Letter from C. R. Steinhardt (WPSC) to Document Control Desk (NRC)

January 27, 1992

Proposed Amendment No. 106

Affected TS Pages

FIGURE TS 4.2-1

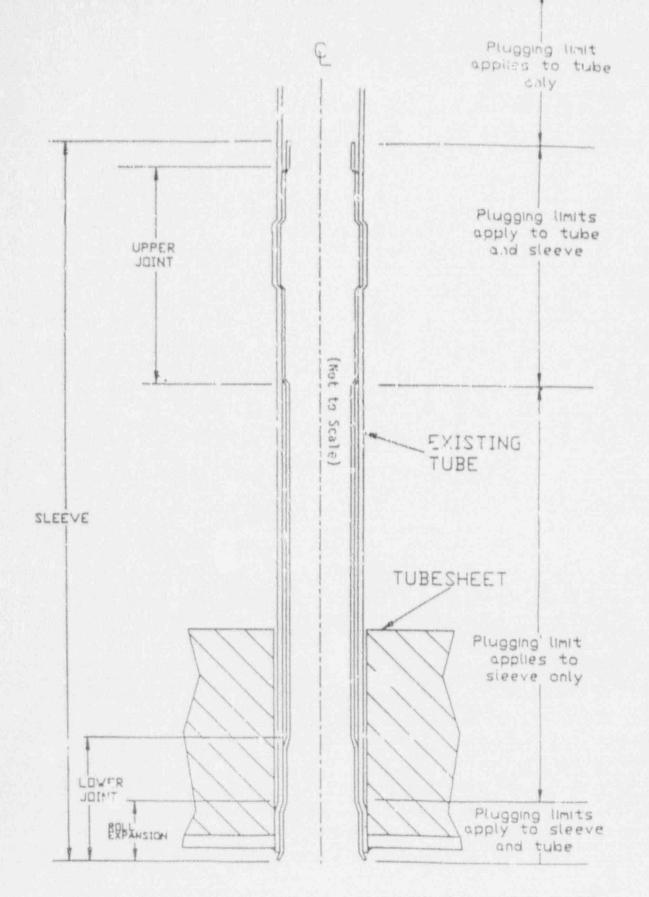
- b. Any Westinghouse mechanical sleeve which, upon inspection, exhibits wall degradation of 31% or more shall be plugged prior to returning the steam generator to service. Figure TS 4.2-1 illustrates the application of tube, sleeve, and tube/sleeve joint plugging limit criteria.
- c. Any Combustion Engineering leak tight sleeve which, upon inspection, exhibits wall degradation of 40% or more shall be plugged prior to returning the steam generator to service. This plugging limit applies to the sleeve up to and including the weld region.
- 5. Hot Leg Tubesheet Crevice Plugging Limit Criteria⁽³⁾

For the Westinghouse mechanical sleeves, the sleeve plugging limi. of 31% is applied to the sleeve as shown on Figure TS 4.2-1. For the Combustion Engineering leak tight sleeves, a plugging limit of 40% is applied to the sleeve and we'd region. The sleeve plugging limits allow for eddy current testing inaccuracies and continued operational degradation per Draft Regulatory Guide 1.121 (August 1976).
